## MR #2024003 – REDLAND ROAD BRIDGE OVER MILL CREEK

### Description

MR2024003  
Prepared October 5, 2023

MCPB Item No. 5  
October 12, 2023

Figure 3: Proposed Bridge Interim Cross Section

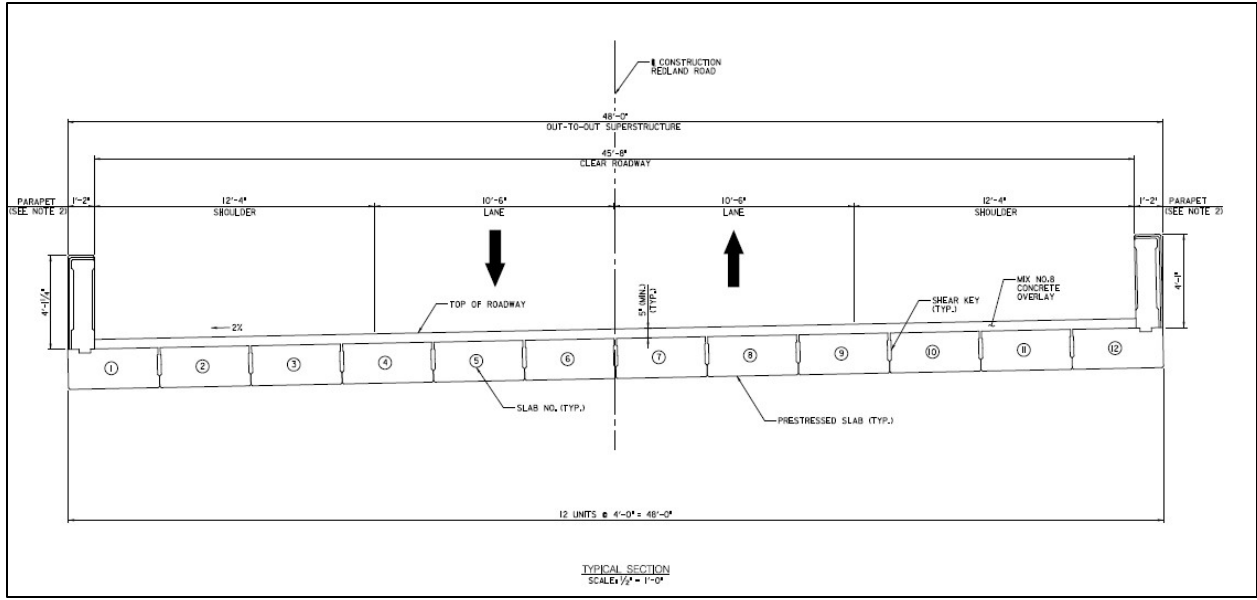
While the travel lanes are designed consistent with the CSDG street type, the use of wide shoulders is inconsistent with this street type. It is anticipated that the ultimate cross section proposed by MCDOT will convert the shoulders to a sidepath, but there are no plans to include a sidewalk on the bridge.

**Recommendation: Develop cross section for the Redland Road bridge that captures the entire master planned vision for the proposed 45 feet 8 inch wide bridge clearance, with the following improvements:**

- a 12-foot wide sidepath on the west side, composed of a 1.5-foot wide buffer from the bridge parapet, an 8-foot-wide sidepath, and a 2.5-foot wide buffer with a protective railing,
- narrow shoulders less than two feet in width,
- two 10.5-foot wide travel lanes,
- a 9-foot wide sidewalk on the east side, composed of a 1.5-foot wide buffer from the bridge parapet, a 5-foot wide sidewalk, and a 2.5-foot wide buffer with a protective railing.

Figure 8: Recommended Bridge Cross Section with Master Plan Vision

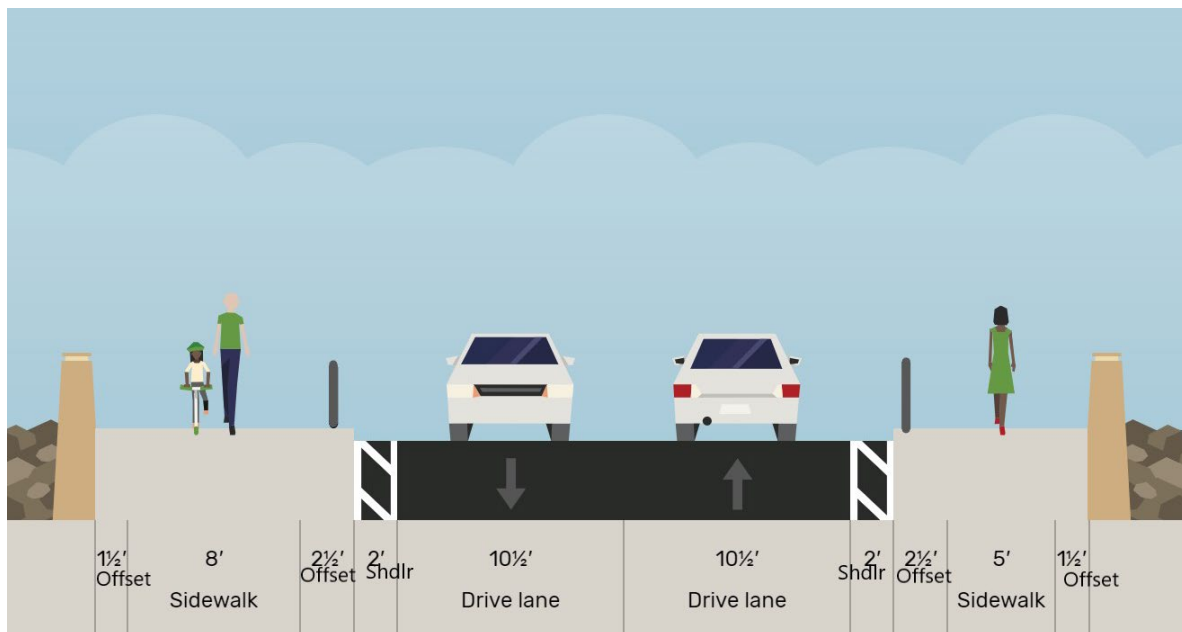
This is illustrated below in Figure 8.

Figure 11: Extent of Stream Work

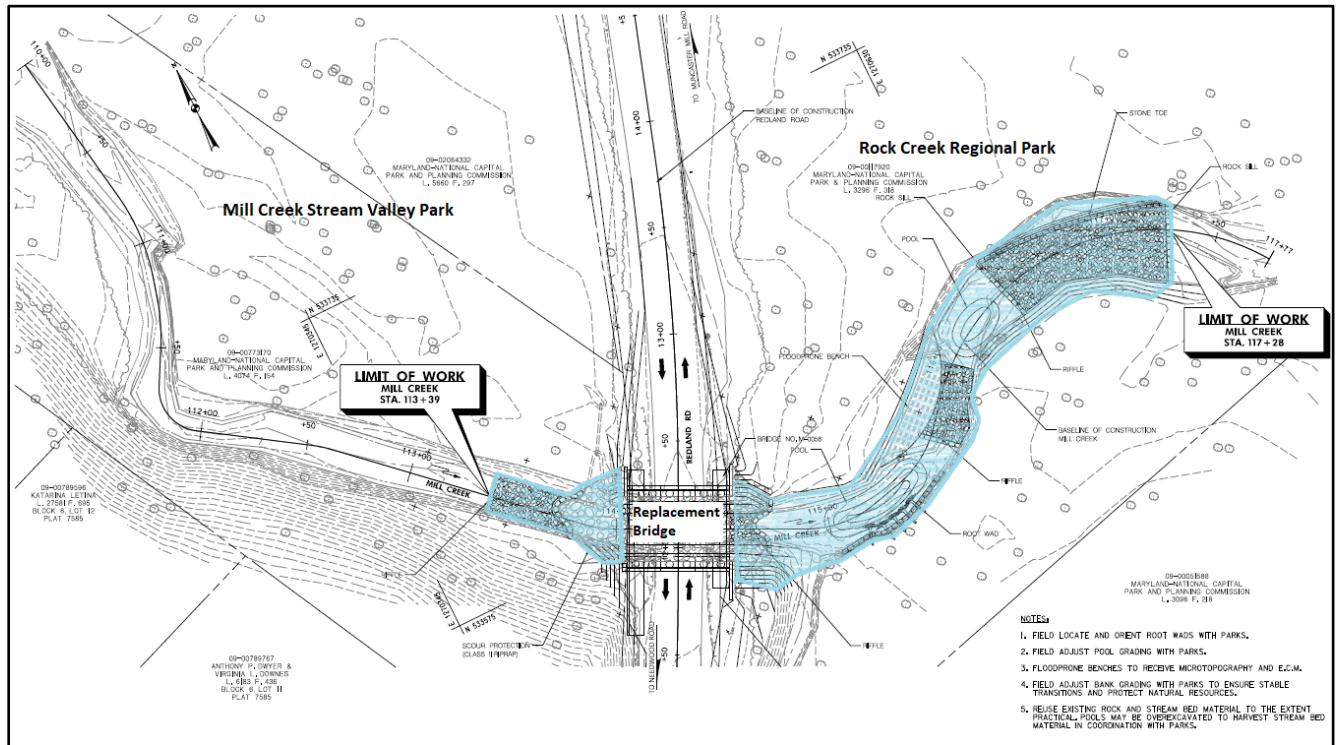
MCDOT will include Natural Channel Design instream stabilization and enhancement features (per Parks Standard Details) upstream (approximately 50 feet) and downstream (approximately 300 feet) of the new bridge as shown below in Figure 11. Traditional bridge construction techniques generally reduce the stream width and harden the banks, which accelerate stream flows and increase the erosive force of the water. Montgomery Parks appreciates MCDOT's commitment to improving the stream condition at Mill Creek by building a new bridge with more capacity for the stream and restoring eroded banks downstream of the bridge. The wider stream cross section under the bridge will result in less erosive flows and improved aquatic passage through the bridge. In addition, stream habitat will be improved by the construction of stable riffles and pools that provide varied aquatic

**Recommendation: MCDOT must continue to coordinate with M-NCPPC on the design of the required in-stream structures in Mill Creek to ensure that a stable stream setting is provided.**

Figure 12: Area of Perpetual Easement for Right-of-Way

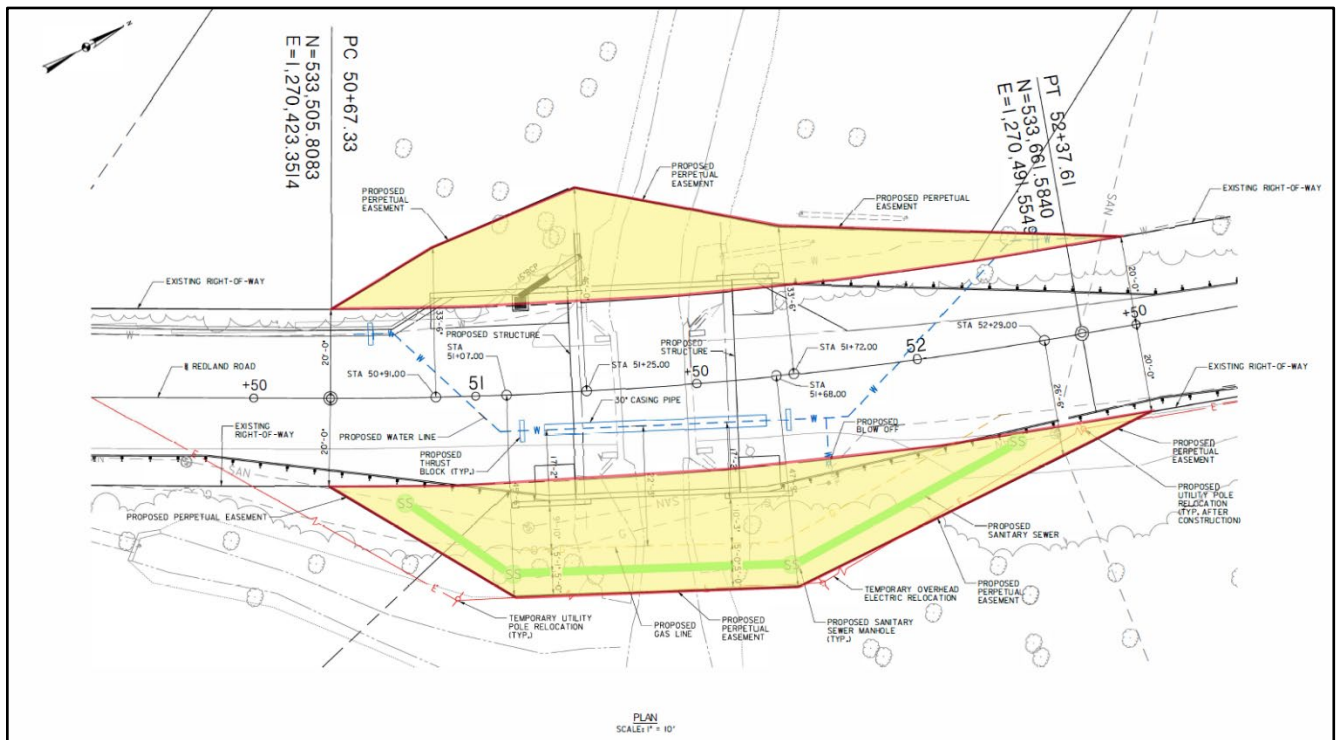
The bridge will require creation of additional MCDOT right-of-way totaling 5,568 square feet consisting of 2,267 square feet in Mill Creek Stream Valley Park and 3,301 square feet in Rock Creek Regional Park. This is shown below in Figure 12.

**Recommendation: Any approved Commission parkland such as Mill Creek Stream Valley Park and Rock Creek Regional Park to be added to the Montgomery County Department of Transportation Road ROW will be transferred to the County, as appropriate, via perpetual easement. The Commission must be paid the fair market value of the perpetual easement. Payment for the Perpetual Easement will occur before issuance of the Park Construction Permit.**
